**Lower Colorado River Authority**  
3700 Lake Austin Blvd.  
Austin, TX 78703

RE: Burnet Quarry  
Application #2024-5606 U0  
Address: 3221 FM 3509, Burnet, TX 78611

**INITIAL CONDITIONS**  
 LCRA PERMITTING - BURNET QUARRY  
 ASPHALT INC.  
 3221 FM 3509, BURNET, TX 78611

**TEMPORARY BMP GENERAL NOTES**  
LCRA PERMITTING – BURNET QUARRY  
ASPHALT, INC.  
3221 FM 3509, BURNET, TX 78611

#### 5.2 DRASTIC Classification

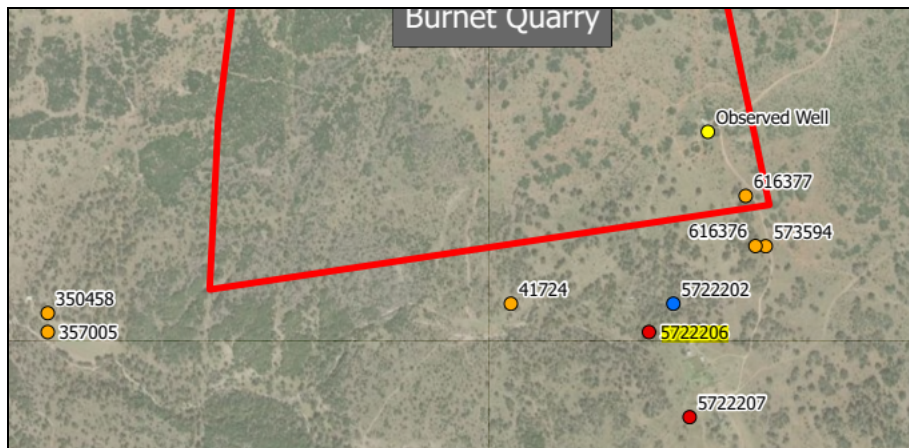
51. Depth to Water Table referenced a well located 0.75 miles NW of the site. This well is not available in the Well & Spring Inventory map. Revise the Depth to Water Table criteria to reference one of the wells illustrated in the Well & Spring Inventory Map.

52. Topography (Slope) documents a 4.61 percent slope for the site and noted a rating of 5. The table documents a rating of 9. Revise the table or noted rating in the narrative.

SHEET NO.: **C.2**  
 OF C.4

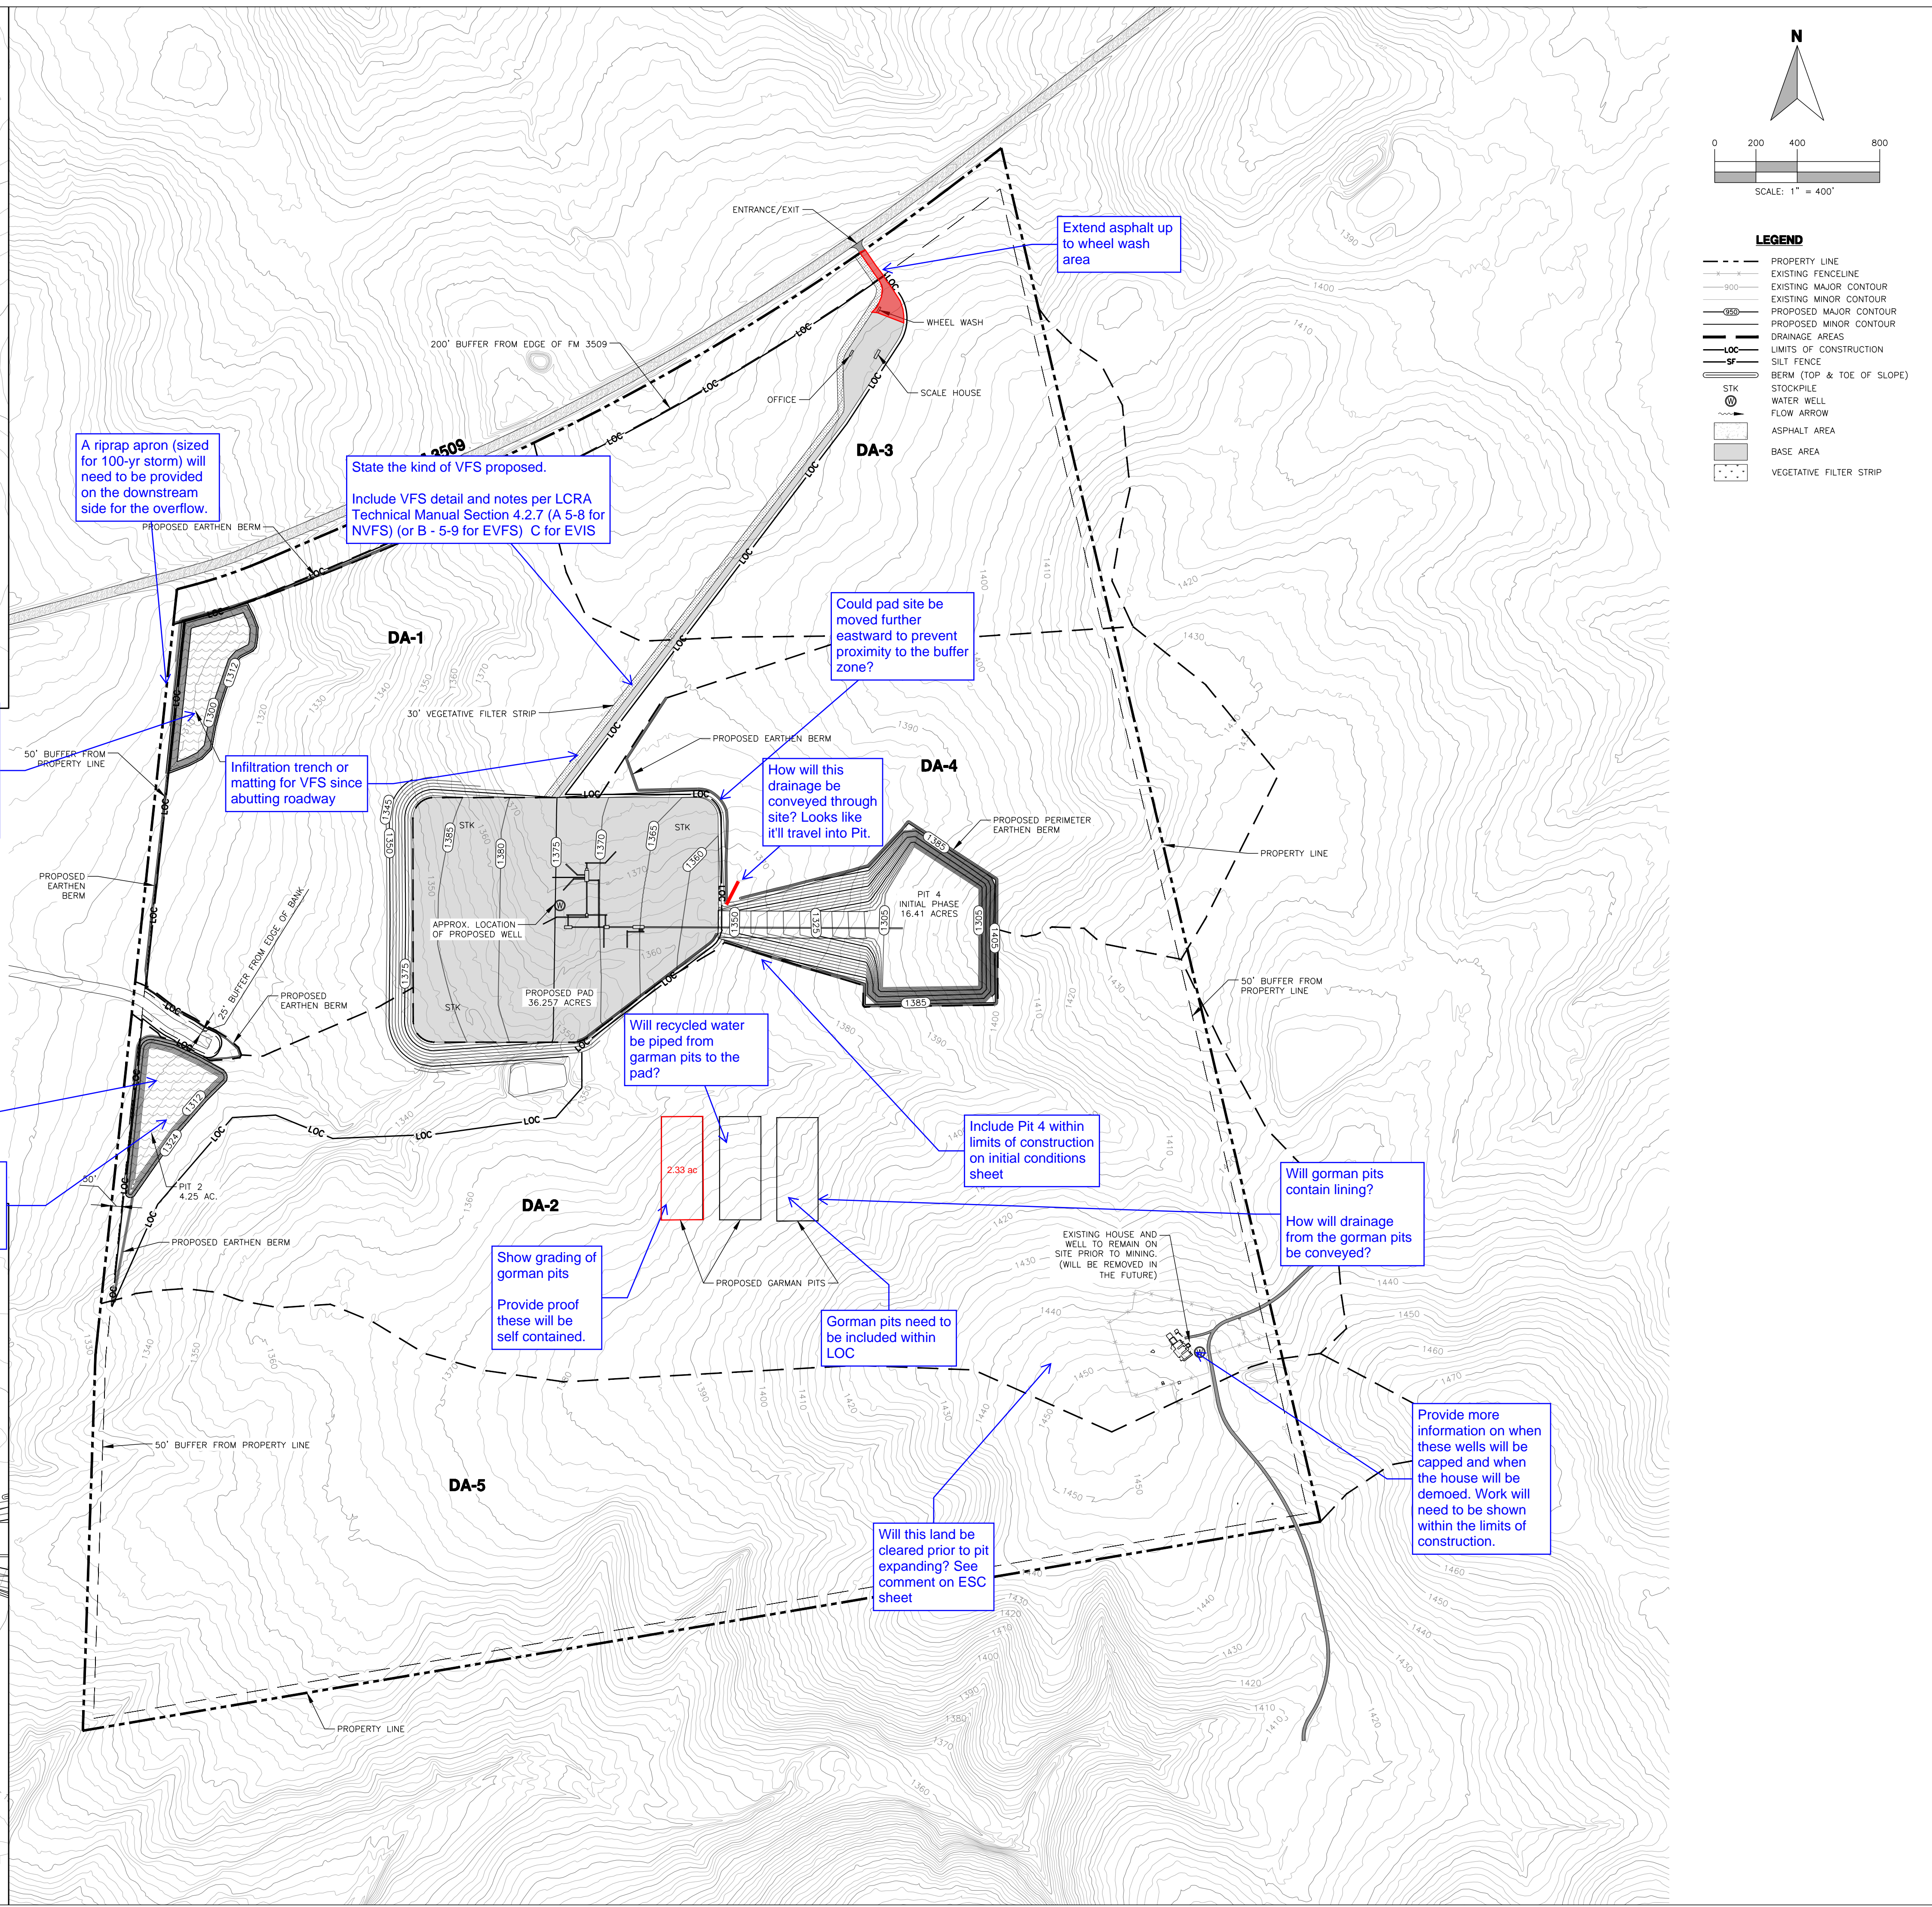
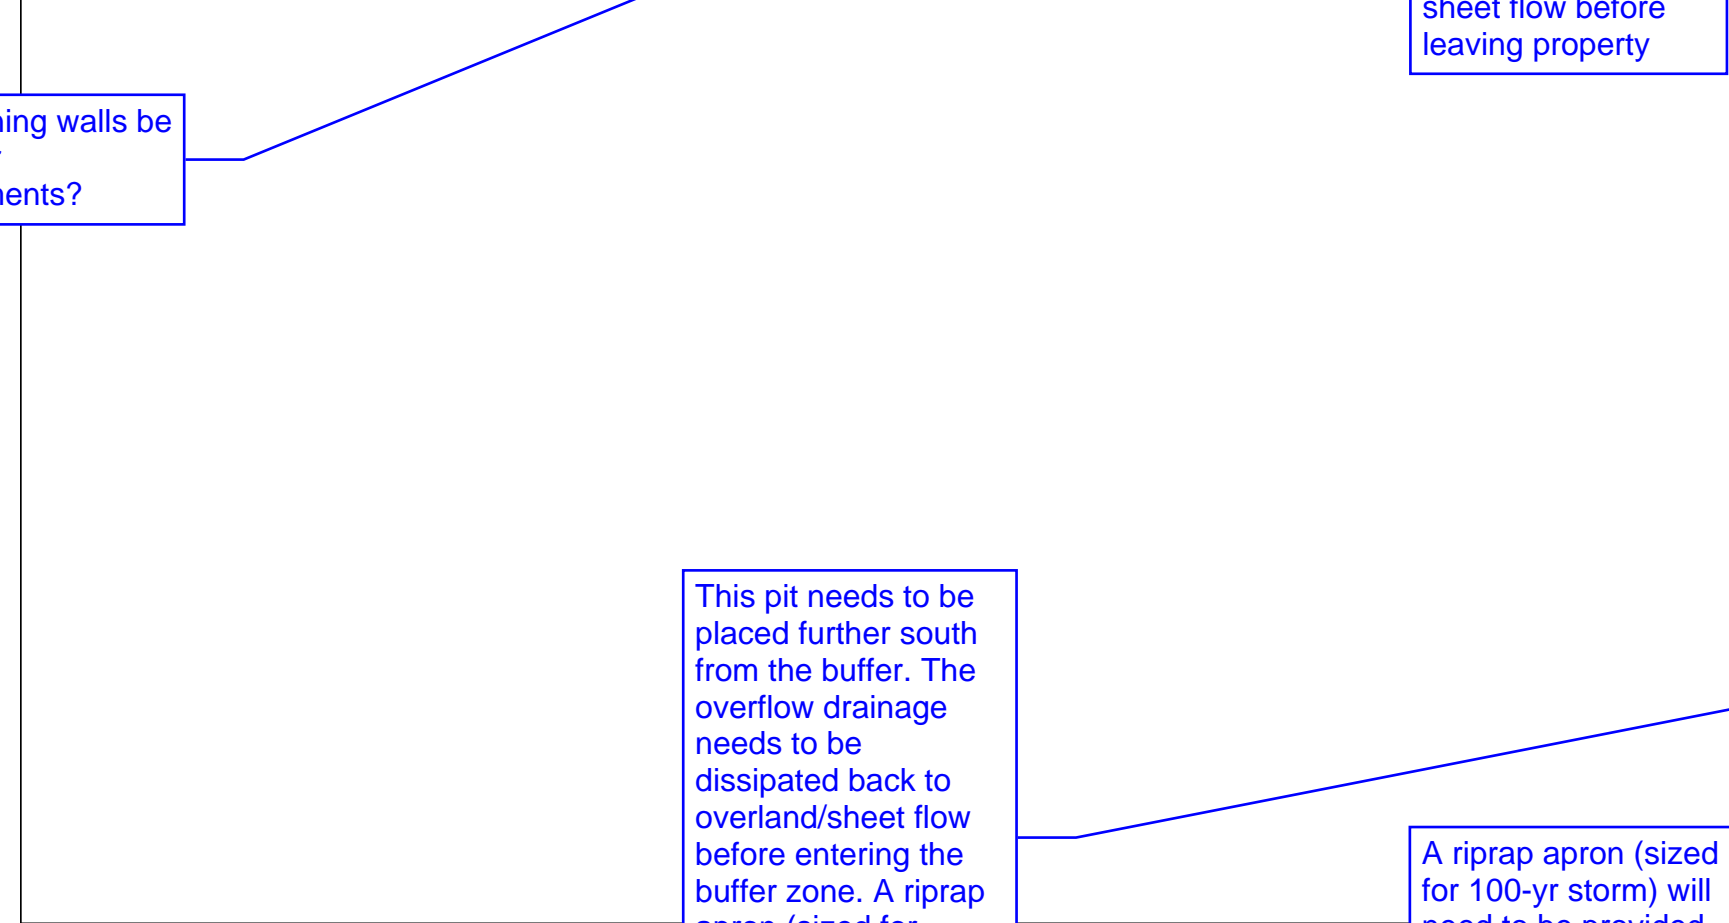
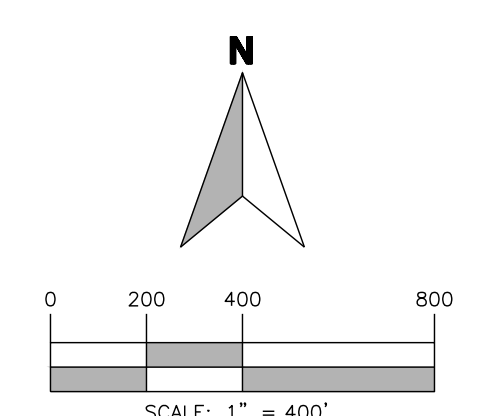
7. Add a quantity and pricing for rock berms, check dams, and high service rock berms. Refer to the markups on sheet C.2 for more information.
8. All proposed work, including the final conditions need to be included within the limits of construction. The total acreage within the limits of construction needs to be the amount of seeding proposed (Seed mixture+ Hydromulching= Acreage within limits of construction).

16. Will the Gorman Pits have a liner installed underneath?
17. It is stated that two Gorman pits are proposed but the initial conditions plan sheet (C.2 of C.4) shows 3 pits with a total acreage of 6.99 acres.

Will retaining walls be utilized or embankments?

Both pit boundaries about to the 50' buffer from the property line. BMP drainage needs to be converted back to sheet flow before leaving property

This pit needs to be placed further south from the buffer. The overflow drainage needs to be dissipated back to overland/sheet flow before entering the buffer zone. A riprap apron (sized for 100-yr storm) will need to be provided on the downstream side for the overflow.

A riprap apron (sized for 100-yr storm) will need to be provided on the downstream side for the overflow.

ed to be in the side of the area to by stockpile draining

Matting needs to be

A riprap apron (sized for 100-yr storm) will need to be provided on the downstream side for the overflow.

State the kind of VFS proposed. Include VFS detail and notes per LCRA Technical Manual Section 4.2.7 (A 5-8 for NVFS) (or B - 5-9 for EVFS) C for EVIS

Could pad site be moved further eastward to prevent proximity to the buffer zone?

How will this drainage be conveyed through site? Looks like it'll travel into Pit.

Infiltration trench or matting for VFS since abutting roadway

Will recycled water be piped from gorman pits to the pad?

Include Pit 4 within limits of construction on initial conditions sheet

Will gorman pits contain lining? How will drainage from the gorman pits be conveyed?

Show grading of gorman pits. Provide proof these will be self contained.

Gorman pits need to be included within LOC

Provide more information on when these wells will be capped and when the house will be demoed. Work will need to be shown within the limits of construction.

Will this land be cleared prior to pit expanding? See comment on ESC sheet

SHEET NO.: **C.4**  
OF C.4

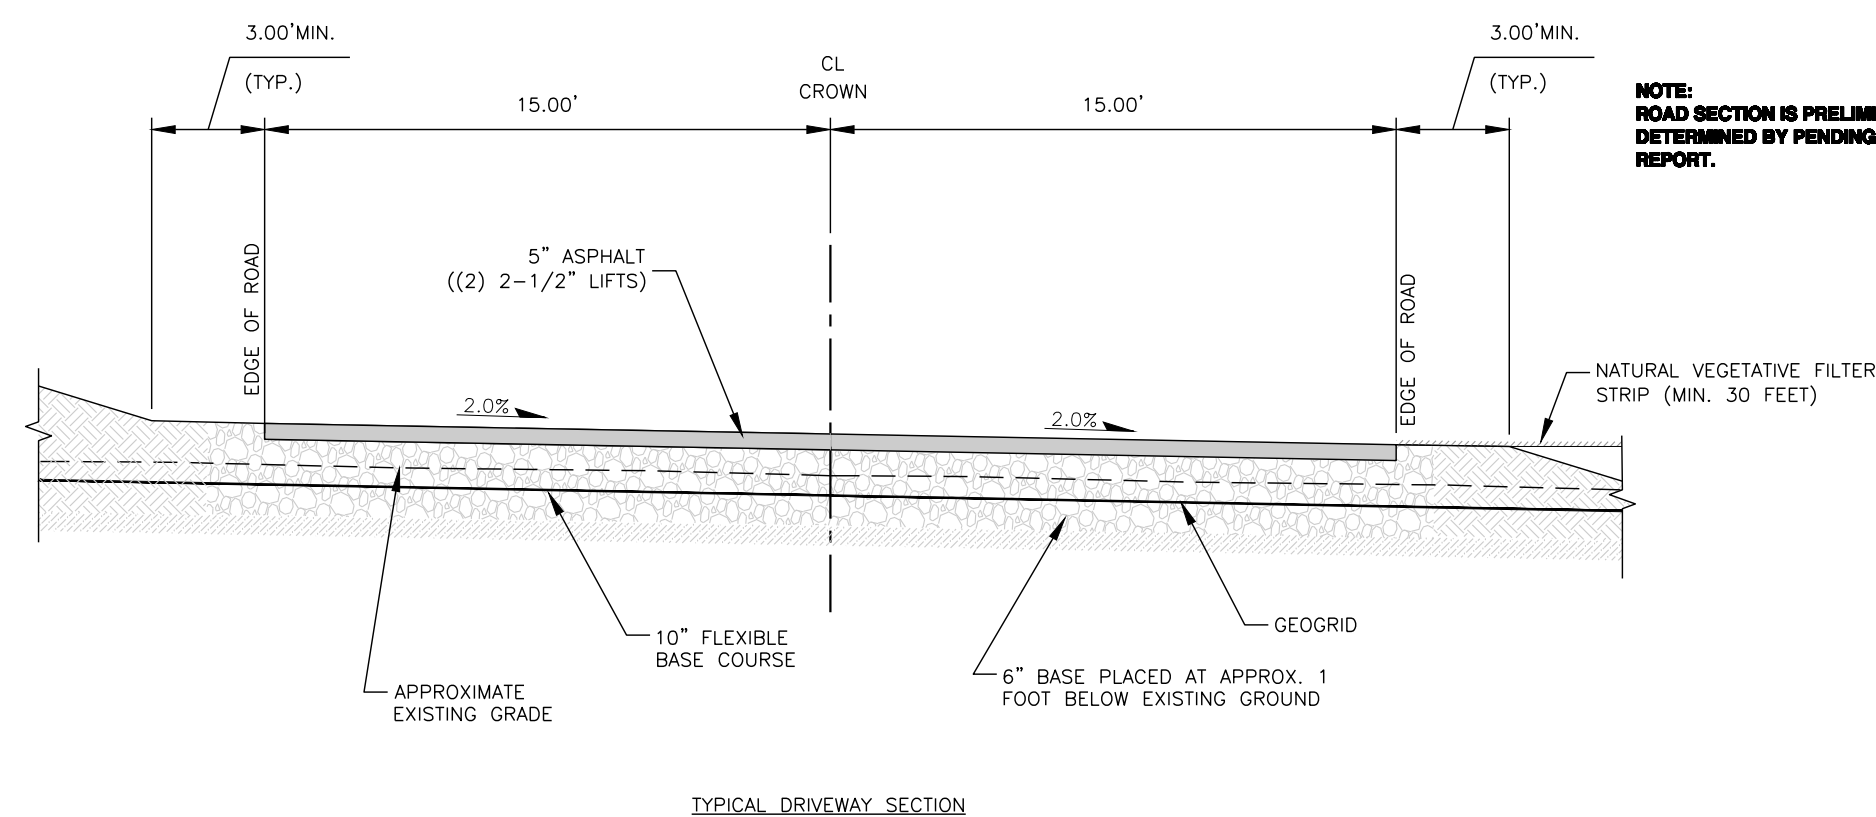
3-6 but the reports states that these ponds will only be constructed on an as needed basis. Please clarify.

Dewatering plans for these pits need to be provided since they will be utilized and temporary sedimentation basins.

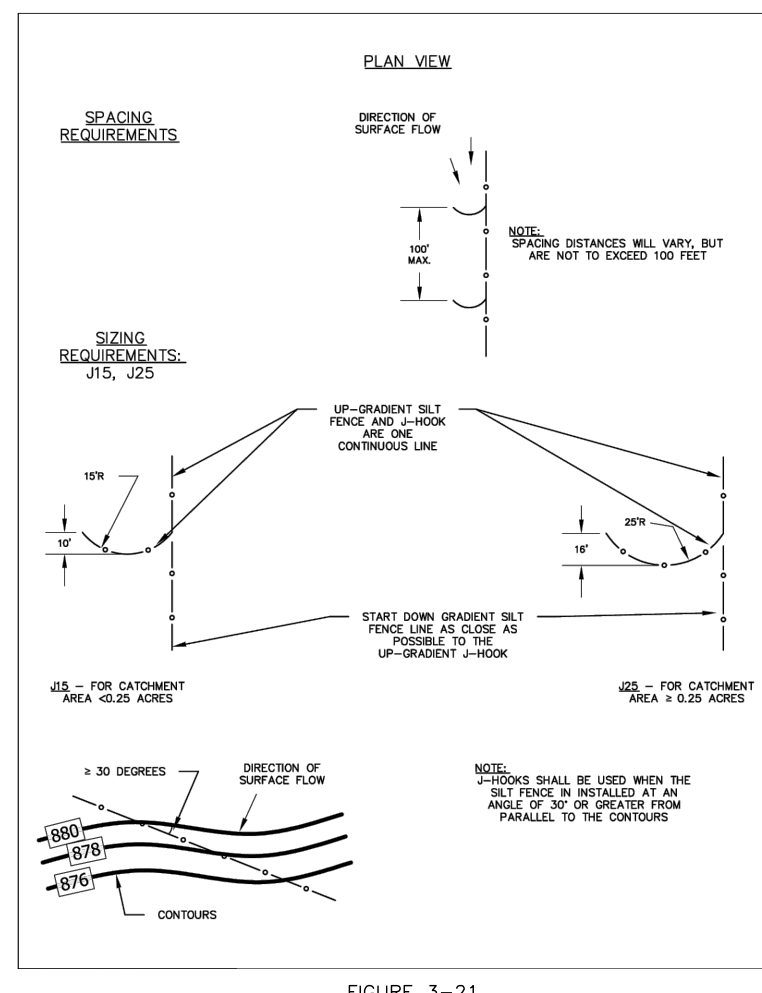
Vegetative filter strip details need to be provided.

Erosion control matting details and installation of erosion control matting details need to be provided

Please provide Creek Crossing details per LCRA Technical Manual Sec. 3.3.16

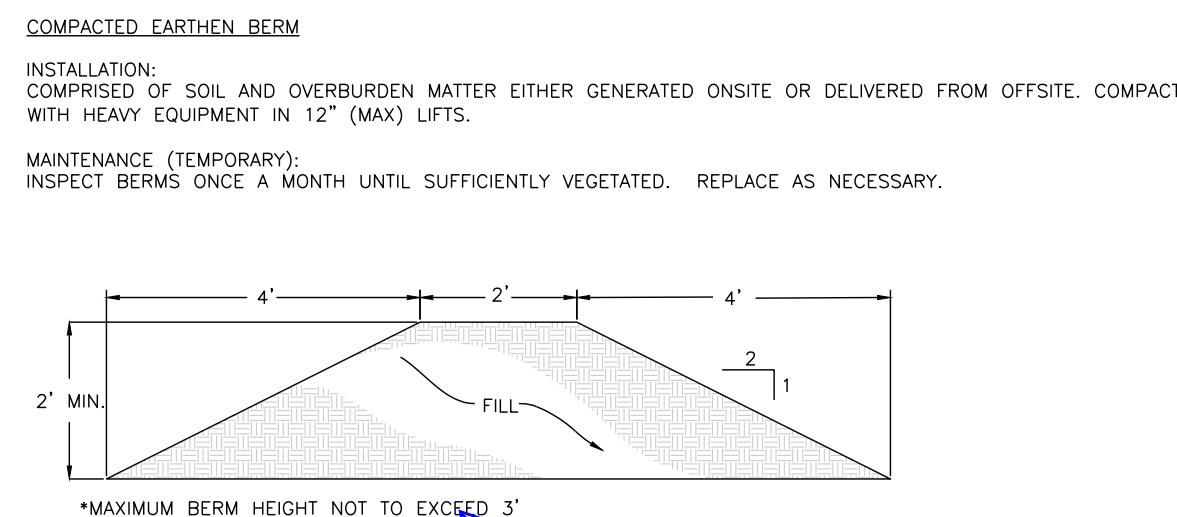
LCRA requires 6' spacing between posts. Refer to Silt fence detail on sheet 346 within the HLWO technical manual.

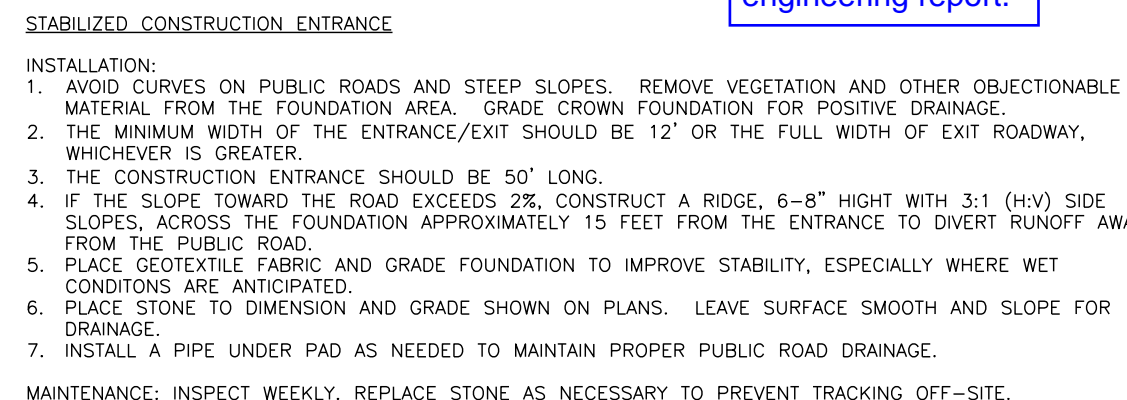
Berm is stated to be a minimum of 4' tall within the engineering report.

Following details need to be provided: -Rock Berm (Sheet 348)
